NORTH ANNA 3 FSER

Figure 2.5.2-7. Map of Changes in Seismicity Rates and B-Values for CEUS-SSC Source Zone ECC-AM, Case A (Figure from Applicant Response to RAI 2.5.2-7.)

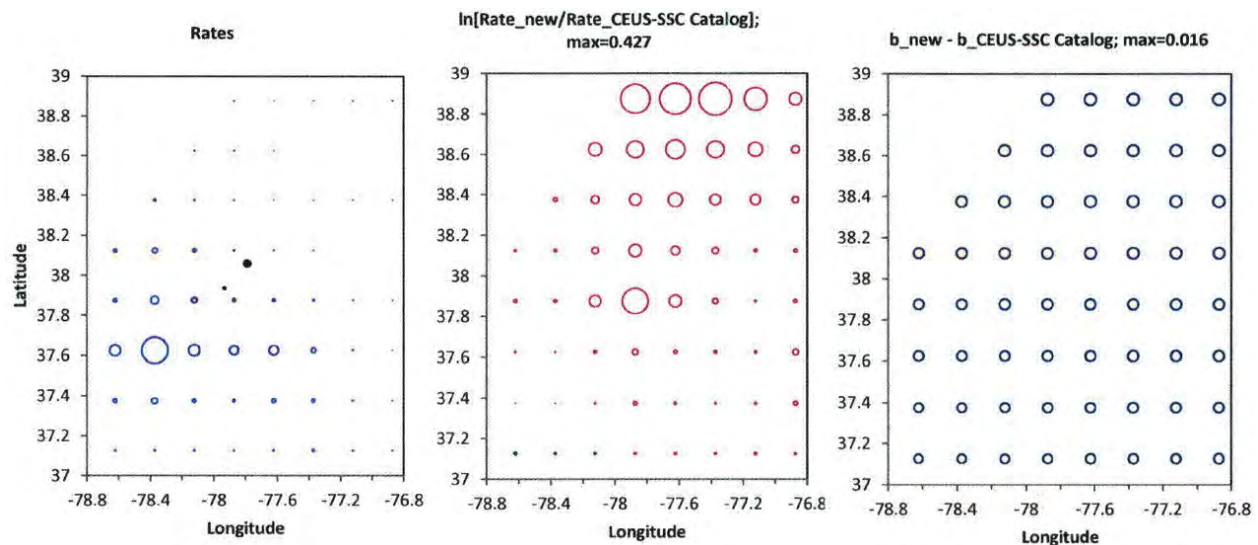
The staff reviewed information provided by the applicant in response to RAIs about the CEUS-SSC catalog updates and the Mineral earthquake. The staff conducted a site audit on May 8, 2014, as documented in ADAMS Accession No. ML14203A179, during which the staff and the applicant discussed the details of their approach to the catalog updates and site response.

Based on the applicant's response, the results of staff's site audit and its independent confirmatory analysis, staff considers RAI 2.5.2-7 resolved and closed.

Figure 2.5.2-8. Comparison of the Applicant's Base Rock Hazard Curves with the Results of the Staff's Confirmatory Analysis

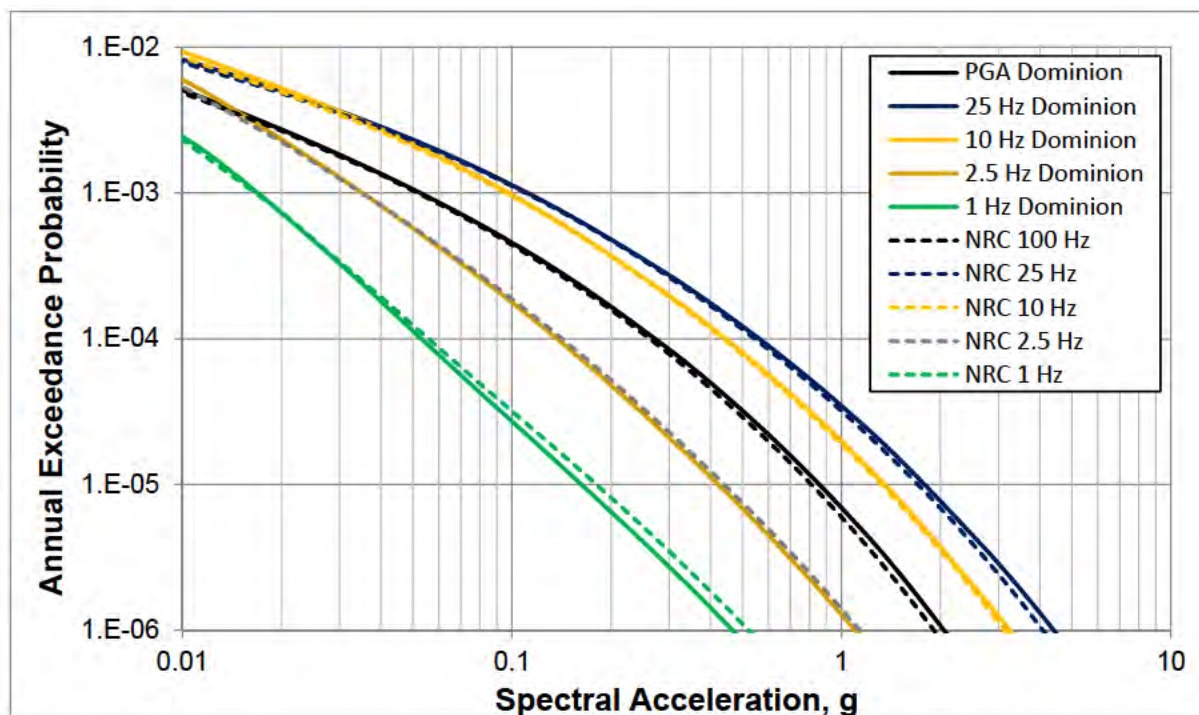
The staff also conducted an independent confirmatory analysis of the PSHA. The staff calculated the hazard at the North Anna 3 site using the published CEUS-SSC for distances up to 500 km (310 mi) for distributed seismicity sources and 1,000 km (620 mi) for RLME sources. In its confirmatory analysis, staff used the EPRI (2013) GMM. Figure 2.5.2-8 of this SER compares the PSHA results from the staff's independent confirmatory analysis with those of the applicant for PGA and frequencies of 25, 10, 2.5, and 1 Hz. The staff's and the applicant's calculations are in acceptable agreement. The staff used its independent PSHA results to develop site specific UHRS at the 10^{-4} and 10^{-5} exceedance frequencies. SER Figure 2.5.2-9 compares 10^{-4} and 10^{-5} UHRS developed by the staff with those developed by the applicant. Because the UHRS results developed by the staff are in acceptable agreement with those developed by the applicant and the applicant has incorporated seismicity after the publication of the CEUS-SSC, including the Mineral earthquake, the staff finds the applicant's PSHA acceptable.

Figure 2.5.2-10. Comparison of the Applicant's Site Amplification Function with the Results of Staff's Confirmatory Analysis

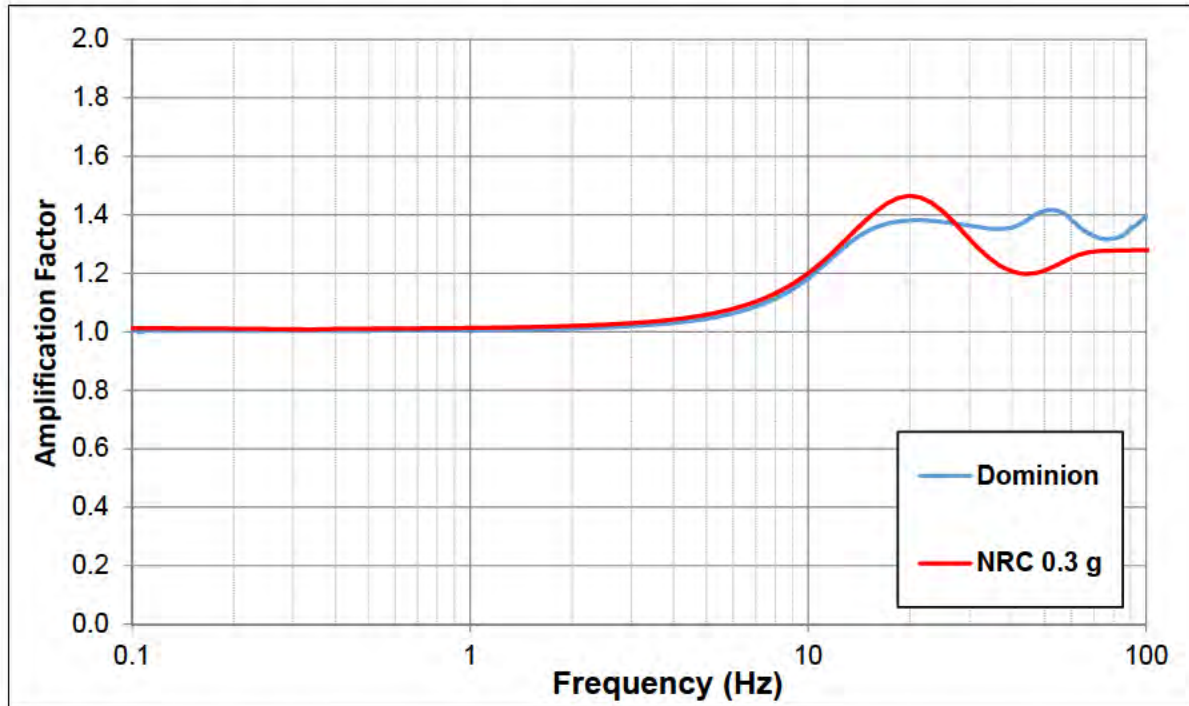
The staff performed a confirmatory analysis of site response using values reported by the applicant for geophysical parameters. The staff independently developed BE velocity profiles, randomized the velocity profile and shear modulus degradation and damping curves and calculated site-specific amplification functions at the GMRS elevation. Figure 2.5.2-10 shows a comparison of amplification functions developed by the staff with those developed by the applicant. The differences in site amplification functions calculated by the staff and the applicant are not significant considering that staff used Approach 3 and the applicant used Approach 2, as described in NUREG/CR-6728, for the site response calculations. The staff subsequently combined its PSHA results at the 10^{-4} and 10^{-5} exceedance frequencies with its amplification functions and calculated a site-specific GMRS. Figure 2.5.2-11 shows a comparison of the site-specific GMRS developed by the staff with that developed by the applicant. The applicant's

Based on the applicant's response to RAIs related to the site response calculations and staff's independent confirmatory analysis that is consistent with the applicant's results, the staff considers RAI 2.5.2-2, RAI 2.5.2-3, and RAI 2.5.2-6 resolved and closed.

Figure 2.5.3-1. LiDAR-derived hillshade map showing locations of key North Anna 3 borings and surface mapped (Mixon et al, 2000) and trench mapped (Dames and Moore, 1973) representations of fault 'a' (from Response to RAI 2.5.1-6d, Figure 1)

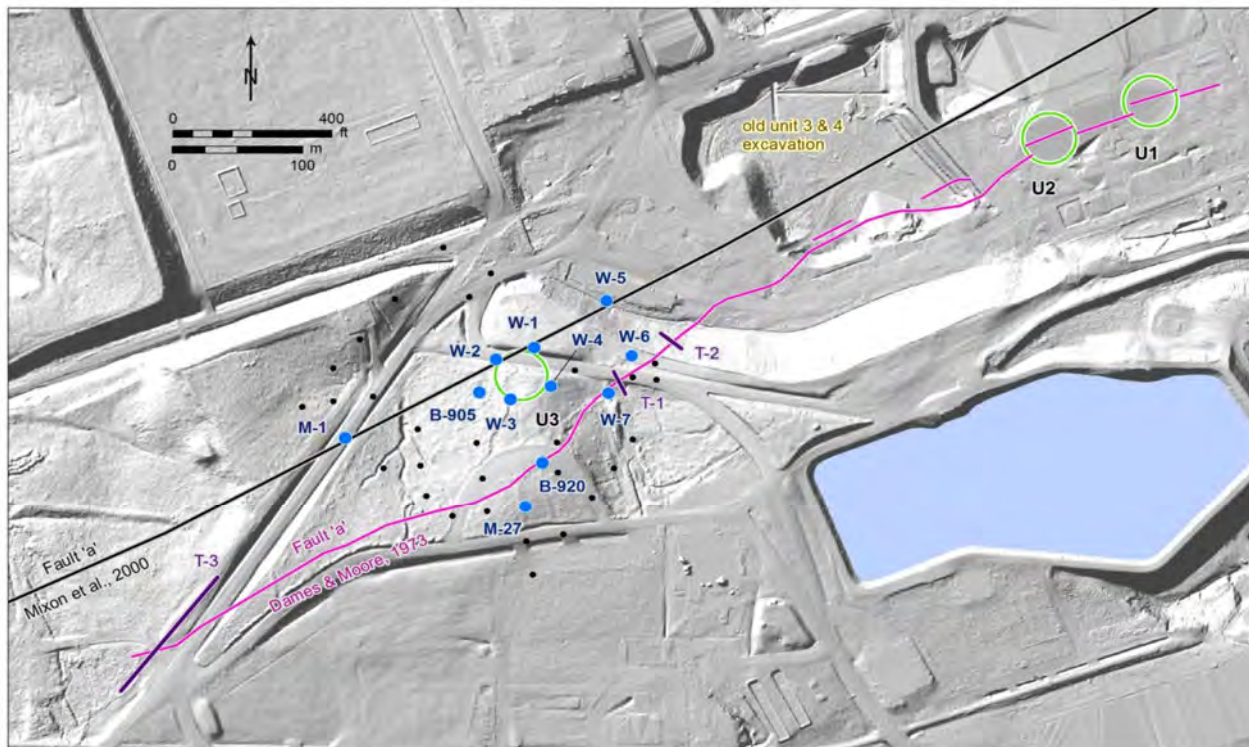
The staff reviewed several Dames and Moore reports from the 1970's regarding fault 'a' (VEPCO, 1974; 1973) in addition to the findings in the ESP SER regarding fault 'a' (NUREG-1835). The shear zone observed in W-1 and W-5 has similar features to fault 'a' but at a much less significant scale. Because the micro-shear zone in W-1 and W-5 is located northwest of fault 'a' and likely also dips northwest, it is structurally higher than fault 'a' (Figure 2.5.3-1 of this report). The staff notes that significant tectonic structures such as fault 'a' typically have a zone of deformation and deformation fabric is not necessarily limited to a single fault plane so the micro-shear zone could be associated with fault 'a'. Regardless of a structural association or not, the deformation associated with fault 'a' was determined to be geologically old, greater than 1 million years old. The staff considers the shear zone in W-1 and W-5 likely to be the same age as fault 'a' and not a potential future surface deformation hazard to the site.

The staff reviewed DCD COL Item 2.0-28-A, which states the ESBWR design requires the applicant to demonstrate that there is no potential for permanent ground deformation at the site area. The staff concludes that the additional information from additional borings in the site area in conjunction with response to RAI 02.05.01-6c, that provides clarification regarding the possibility of finding major shear zones in the borings as opposed to determining specifically Quaternary fault movement, that there is sufficient subsurface information to resolve DCD COL Item 2.0-28-A. Accordingly and in compliance with 10 CFR 100.23 and 10 CFR 52.79, the staff considers RAI 02.05.01-6c resolved and closed.
